ULNRC- 04558

**DOCKET NUMBER 50-483
CALLAWAY PLANT
UNION ELECTRIC COMPANY
RESPONSE TO REQUEST FOR ADDITIONAL INFORMATION
ON REVISION TO TECHNICAL SPECIFICATION 5.5.9
"STEAM GENERATOR (SG) TUBE SURVEILLANCE PROGRAM"**

**REQUEST FOR ADDITIONAL INFORMATION
REVIEW OF THE CALLAWAY PLANT APPLICATION
FOR REVISION TO TECHNICAL SPECIFICATION 3/4.4
TAC NUMBER: MB1214**

Figure R30-1

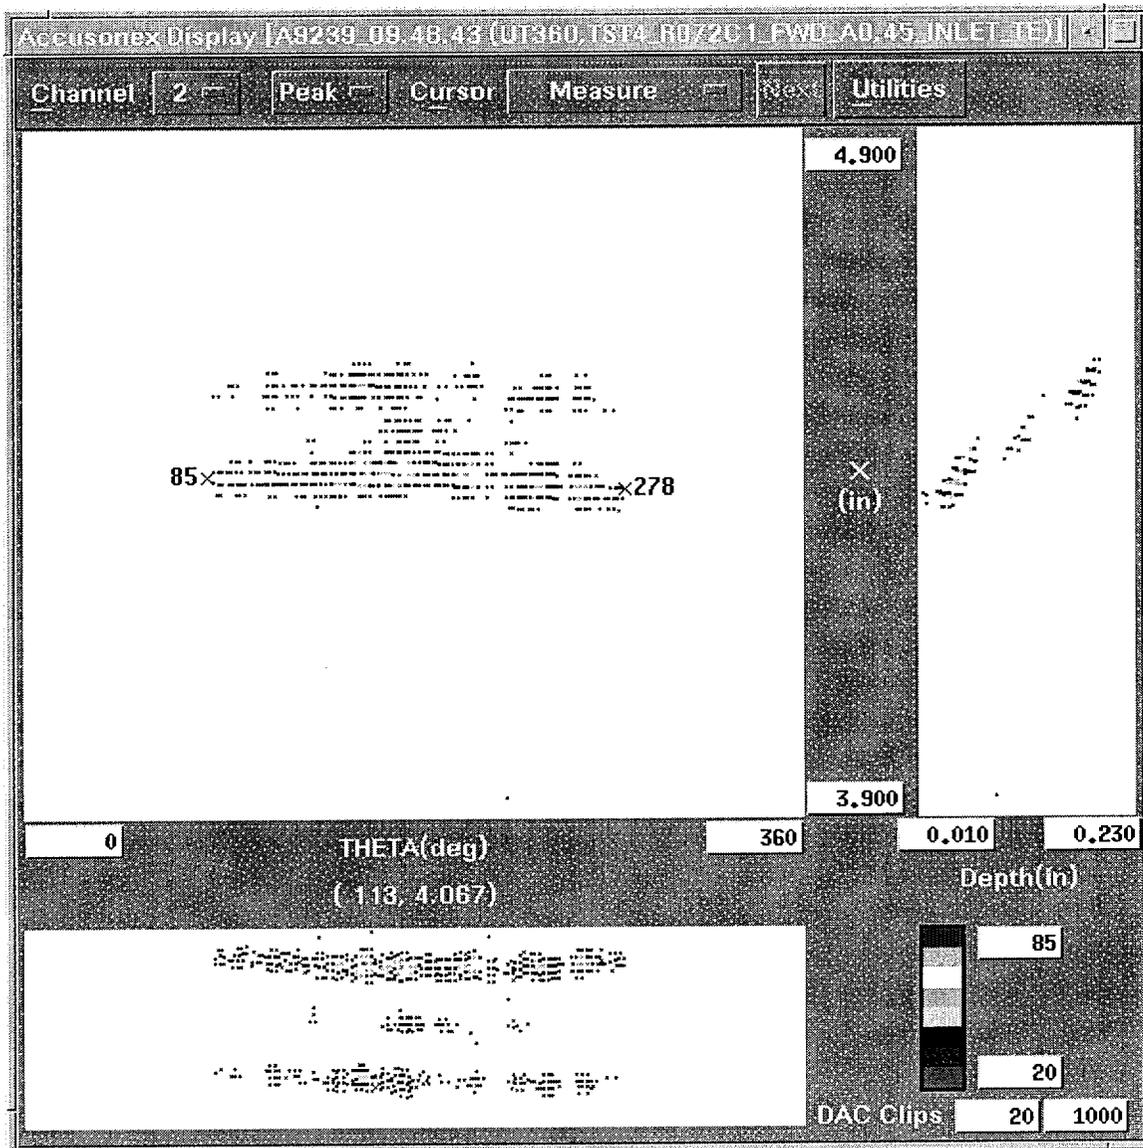
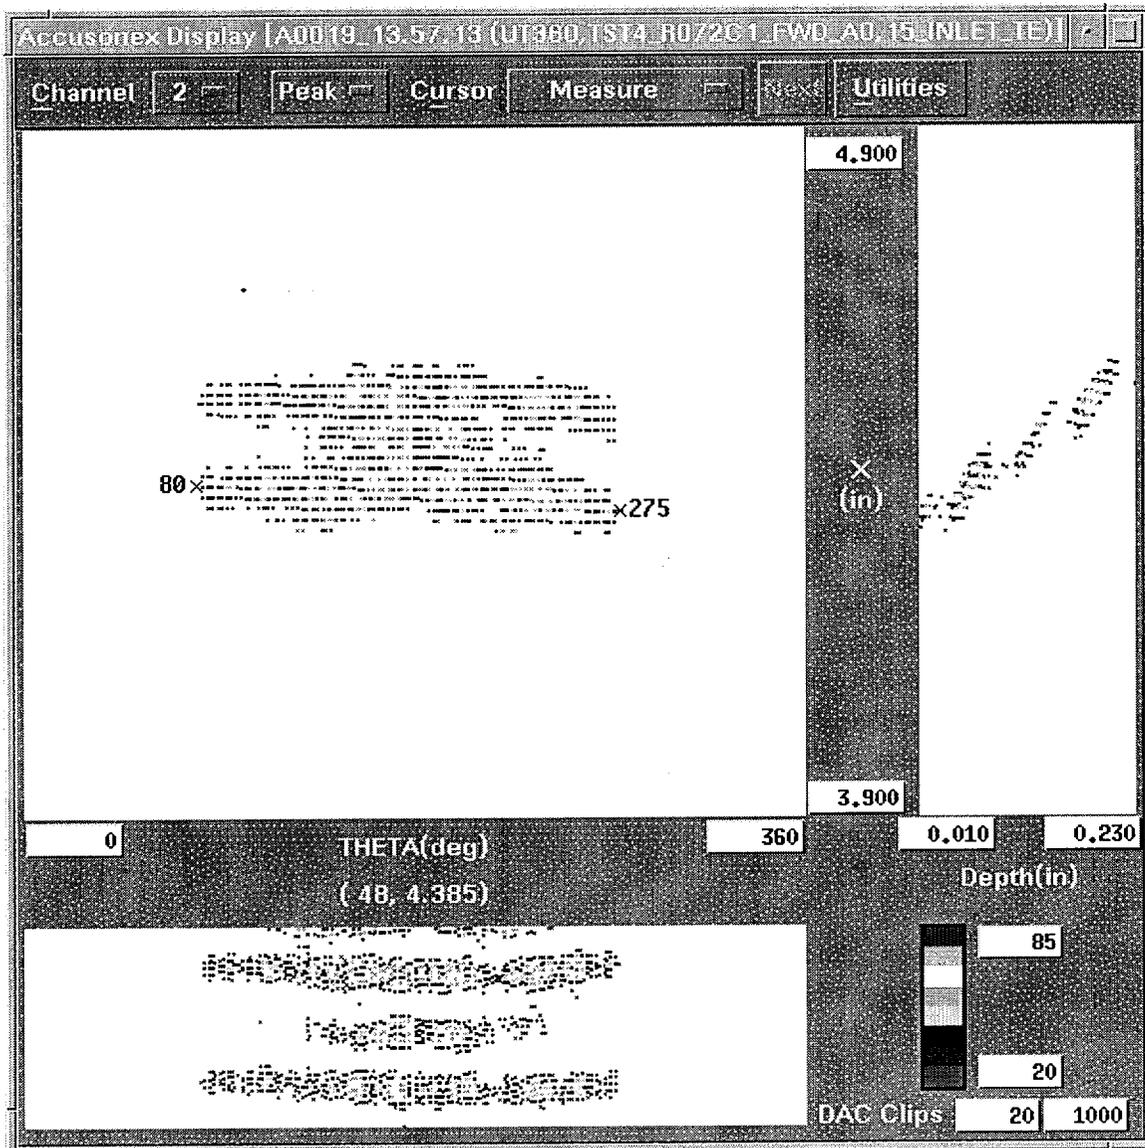
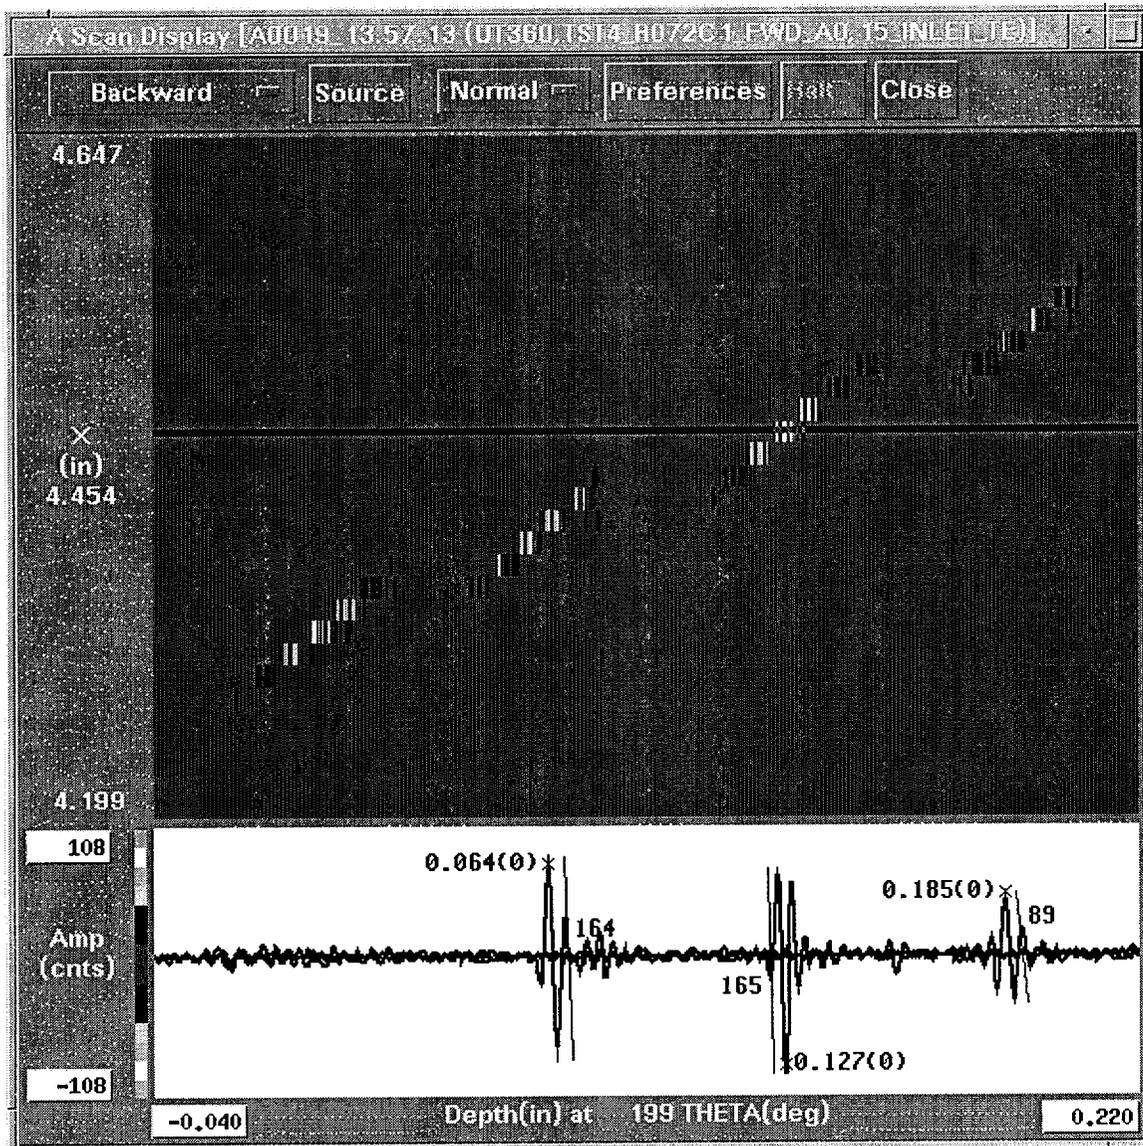
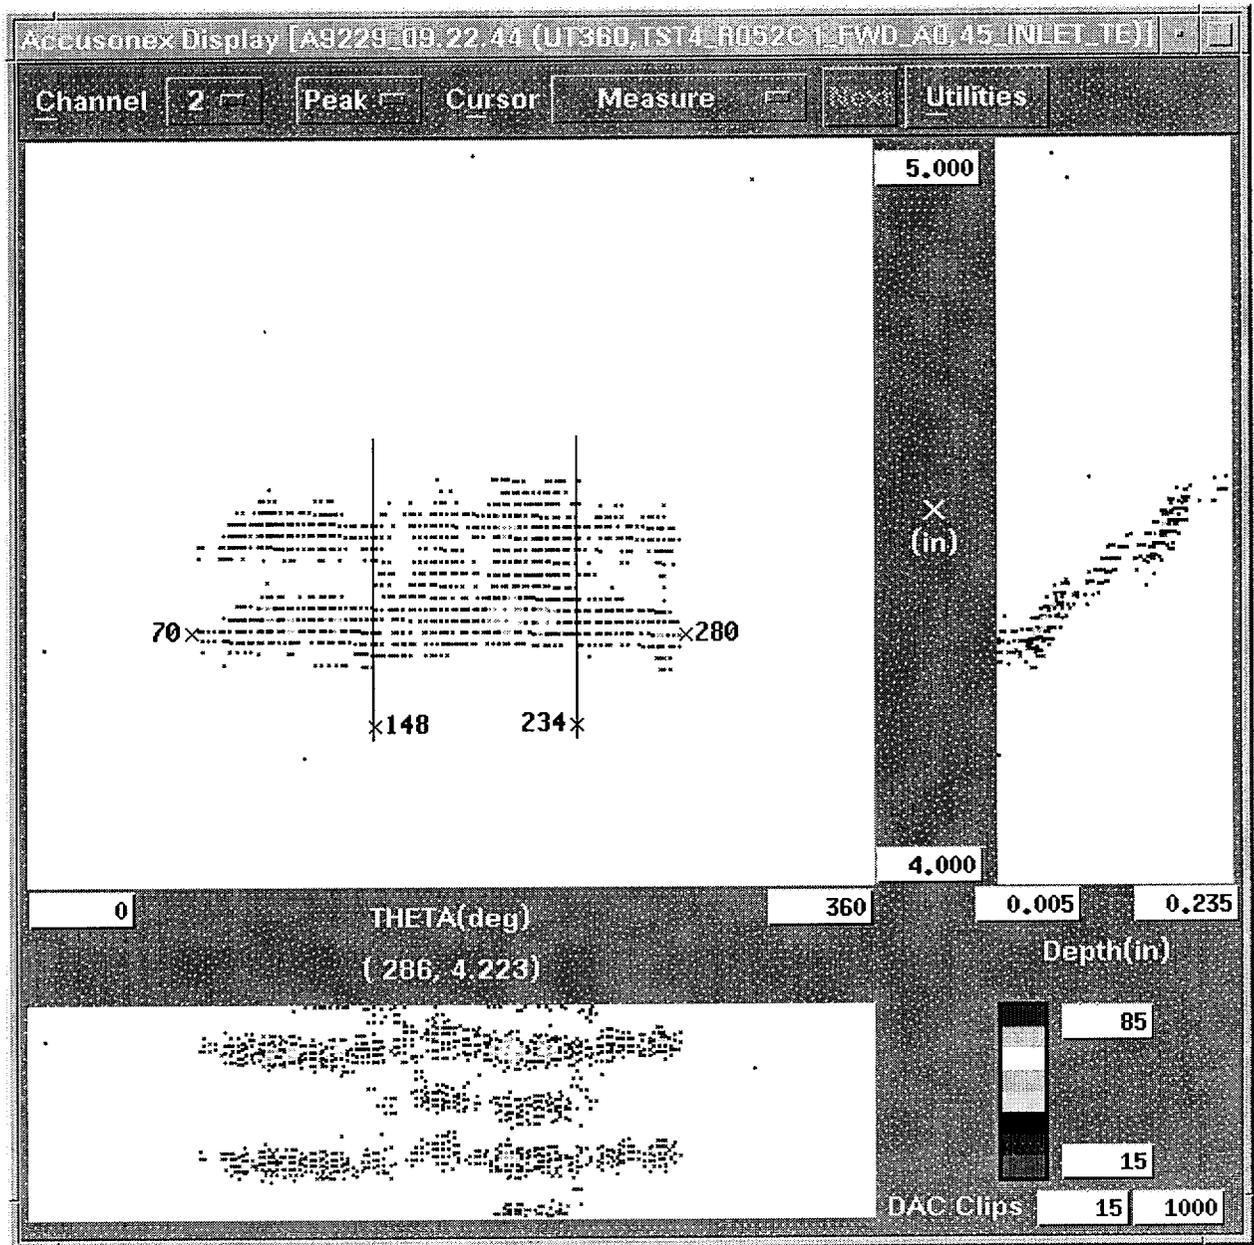
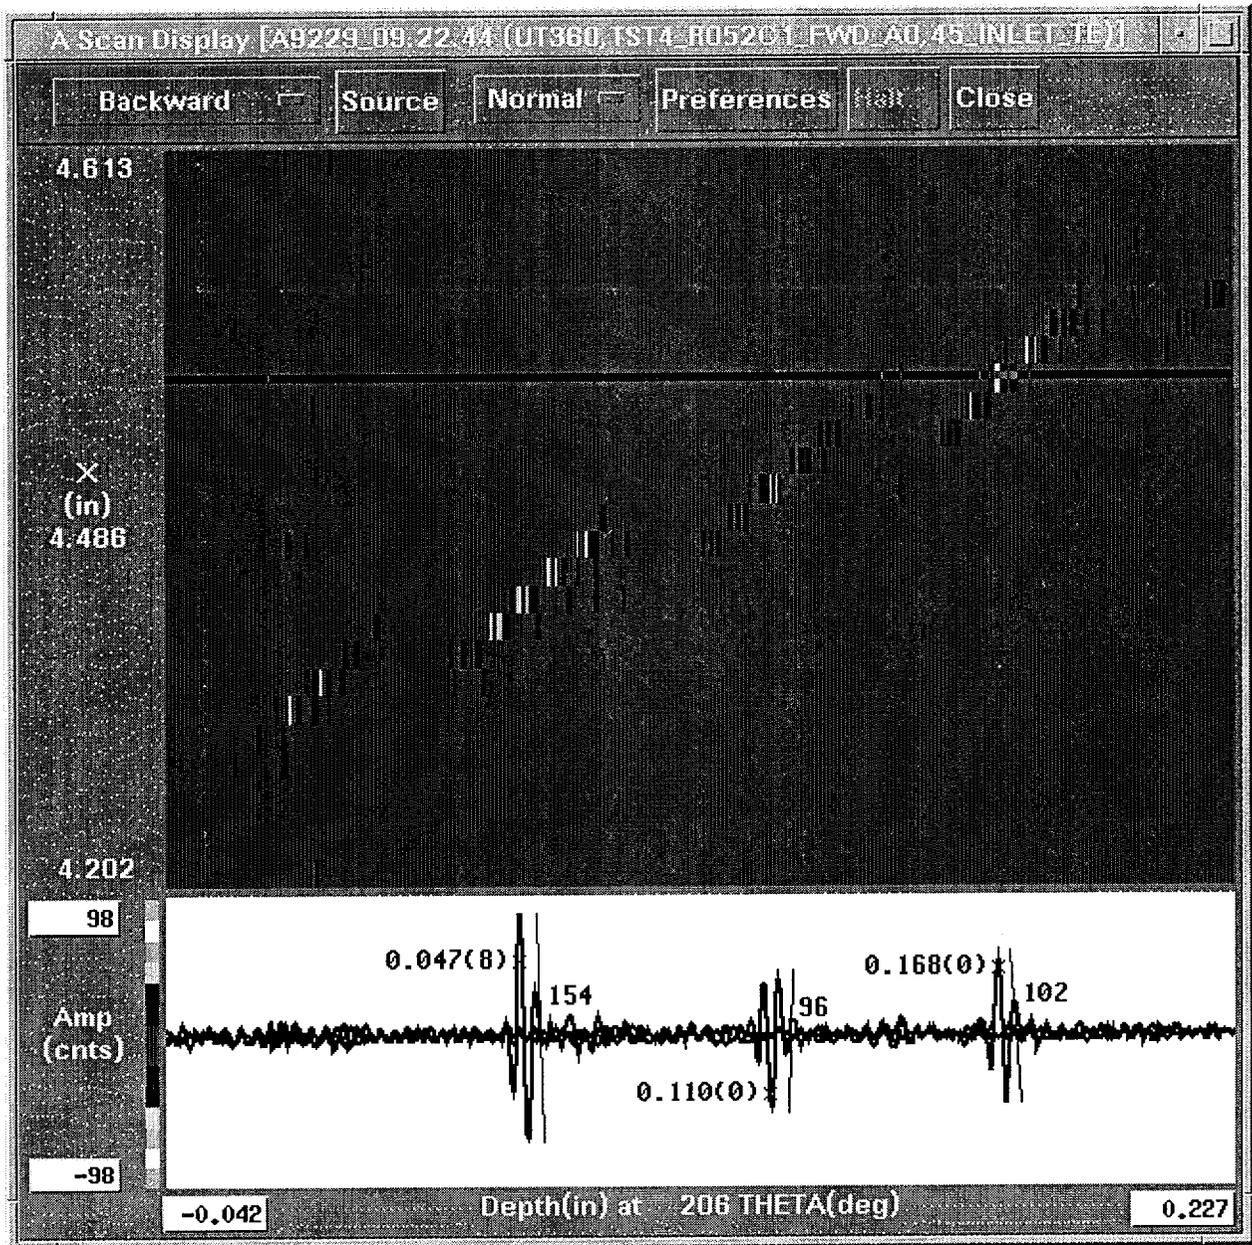
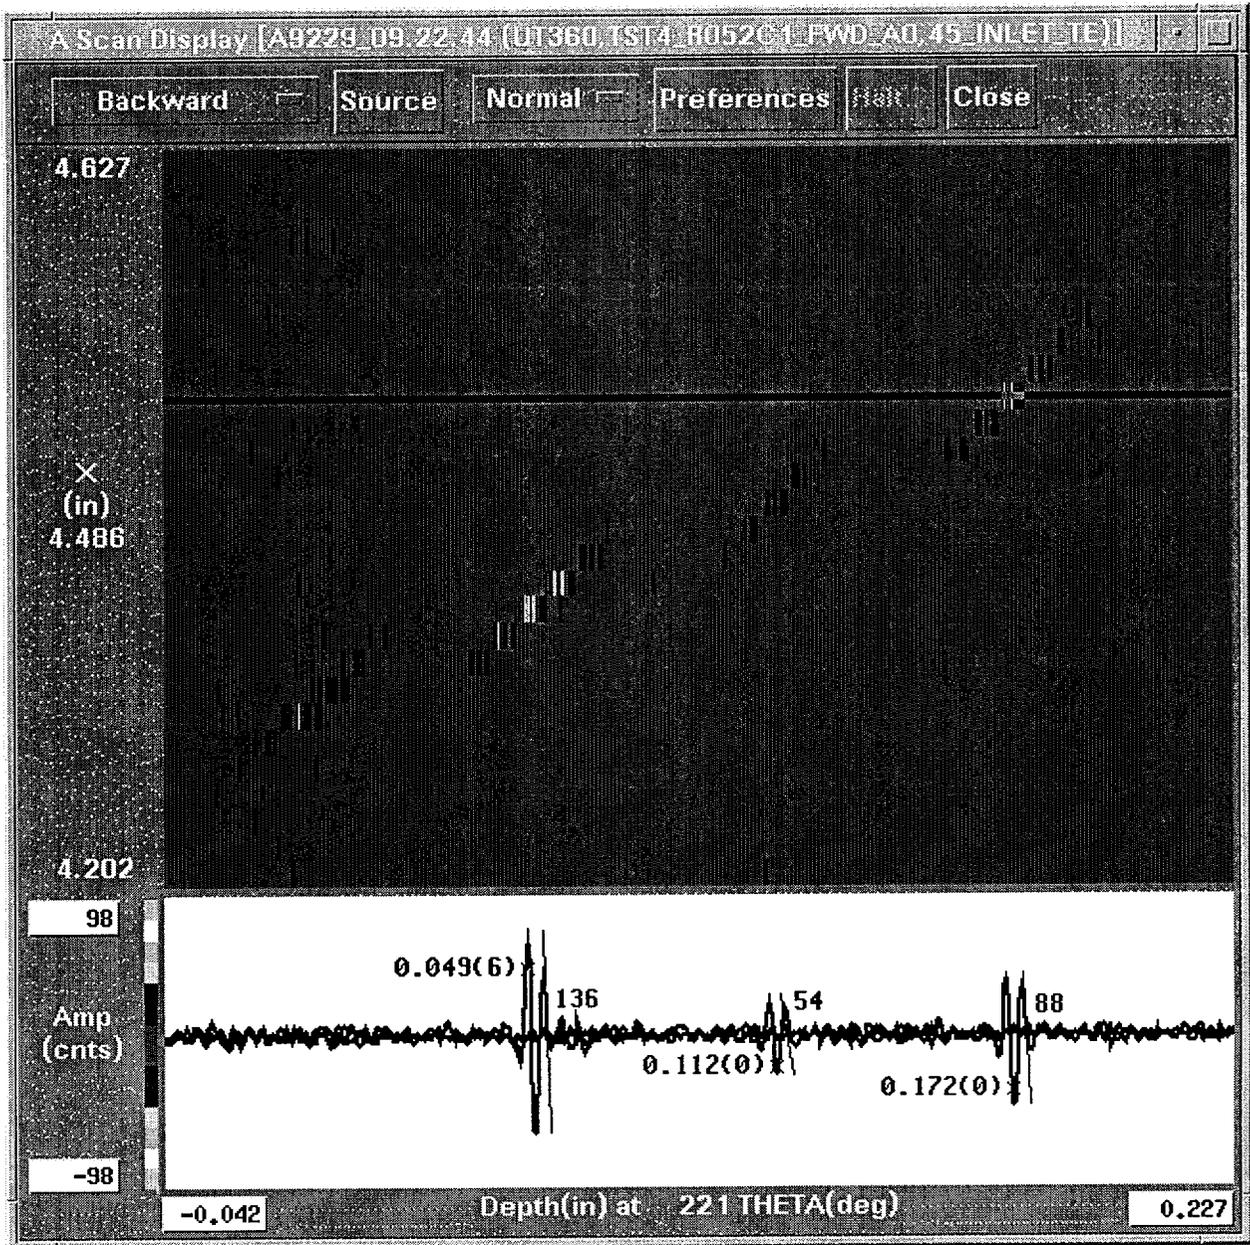
RAI # 30. The report states that “UT techniques have been shown to be effective in the detection and sizing of fatigue cracks propagated into the sleeve material.” Please provide data to support this assertion. (Page 11-57, BAW-10219P, Rev. 4)

This is the pre-fatigue crack C-Scan plot of the ODSCC circumferential crack in tube TST4-072-1. The crack extent (length) can be estimated from the C-Scan plot as $(278 - 85)$ or 193 degrees. The plot shows the presence of a half skip response, a one and one half skip response and some full skip reflections.

This is the post-fatigue crack C-Scan plot of the ODSCC circumferential crack in tube TST4-072-1. The crack extent (length) can be estimated from the C-Scan plot as $(275 - 80)$ or 195 degrees. The fatigue cycling has not significantly increased the crack extent (length). The plot shows the presence of a half skip response, a one and one half skip response and an increase in the full skip response.

This is the pre-fatigue crack C-Scan plot of the ODSCC circumferential crack in tube TST4-052-1. The crack extent (length) can be estimated from the C-Scan plot as $(280 - 70)$ or 210 degrees. The plot shows the presence of a half skip response, a one and one half skip response and some full skip reflections between the 148 degree and 234 degree locations along the crack extent.

This is the post fatigue crack C-Scan plot of the ODSCC circumferential crack in tube TST4-052-1. The crack extent (length) can be estimated from the C-Scan plot as $(280 - 70)$ or 210 degrees. The plot shows the presence of a half skip response, a one and one half skip response and an increase in the full skip response between the 200 degree and 230 degree locations along the crack extent.

This is the post final deposition C-Scan plot of the ODSCC circumferential crack in tube TST4-052-1. The crack extent (length) can be estimated from the C-Scan plot as $(275 - 70)$ or 205 degrees. The plot shows the presence of a half skip response, a one and one half skip response and the diminished amplitude of the full skip response.
